Response to Eighth Request for Additional Information Regarding ANP-10285P, "Fuel Assembly Mechanical Design Topical Report"

Response to Eighth Request for Additional Information – ANP-10285P
“U.S. EPR Fuel Assembly Mechanical Design Topical Report”

RAI 72: *Addressing Damping Assumptions for U.S. EPR Fuel Seismic Response Analysis with Detailed Regulatory Basis***Background**

**Figure 72-1— Complete Loss of Forced Reactor Coolant Flow Event - RCS
Flow Rates**

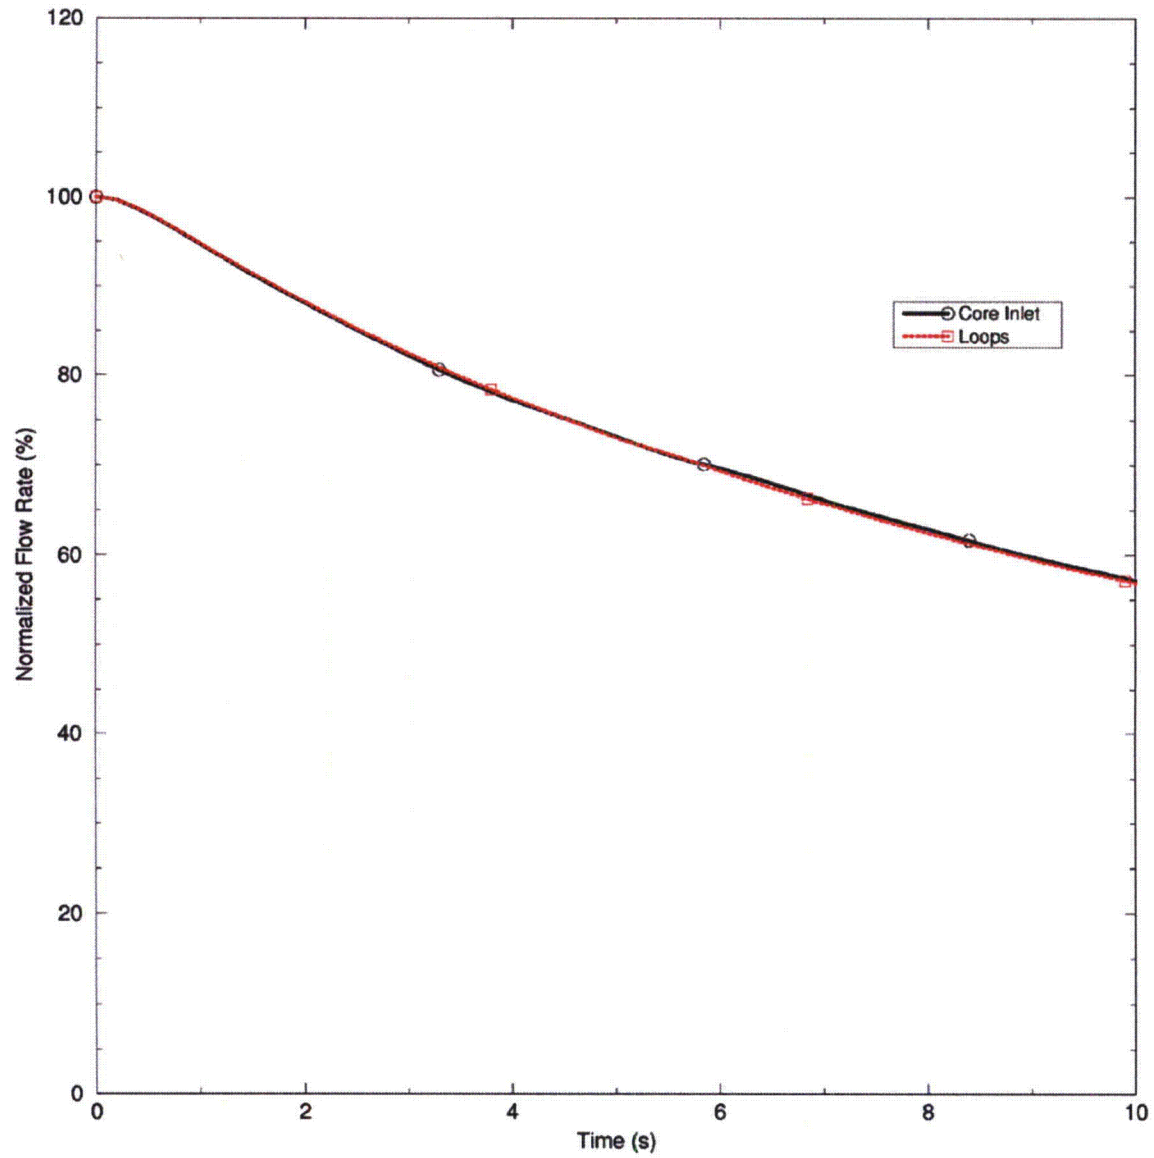
SRP Section 4.2, Appendix A discusses fuel coolability criteria related to a loss-of-coolant accident (LOCA), which is based on the assumption of combined loads, and addresses the impact on the ECCS analysis. The U.S. EPR design has shown that it may be necessary to perform additional coolability and control rod insertability evaluations above decay heat power levels, including full power operation, in order to address permanent spacer grid deformation caused by spacer grid impact forces that do not exceed $P(\text{crit})$ under SSE-only loads.

Since the assumed critical damping ratio has a direct impact on the predicted spacer grid impact loads, it will also have a direct impact on the amount of permanent grid deformation that is predicted. Therefore, the predicted permanent grid deformation resulting from a reduced critical damping ratio during a LOOP following a seismic event should be evaluated for the U.S. EPR design with respect to control rod insertability and fuel rod coolability.

Justify the critical damping ratio used in the fuel assembly structural response analysis for the U.S. EPR. Address the following points in your response:

- a. Quantify any change to the critical damping ratio assumed in the analysis based on RCP coastdown considerations.*
- b. Include considerations for both the unirradiated and irradiated cases. Additionally, provide the Rayleigh damping coefficients being used for the irradiated fuel assembly cases in the fuel assembly structural response analysis for the U.S. EPR.*
- c. Quantify the damping ratio margin (i.e. the difference between the critical damping ratio derived from test data and that credited in the analysis) change for both the unirradiated and irradiated fuel assembly cases.*

The SSE+LOOP event is equivalent to the Complete Loss of Forced Reactor Coolant Flow, which is an AOO analyzed in U.S. EPR FSAR Tier 2, Chapter 15, Section 15.3.2. The plots of the normalized RCS flow rate, and pressurizer pressure for this transient are shown in Figure 72-1 and Figure 72-2. The sequence of events is as follows:

- The RCP flow fractions during the key time points of the LOOP event are shown in Table 72-1. The time corresponding to complete control insertion will be used to define the flow for the purpose of demonstrating the applicability of the damping model used in the fuel assembly spacer grid load analysis.
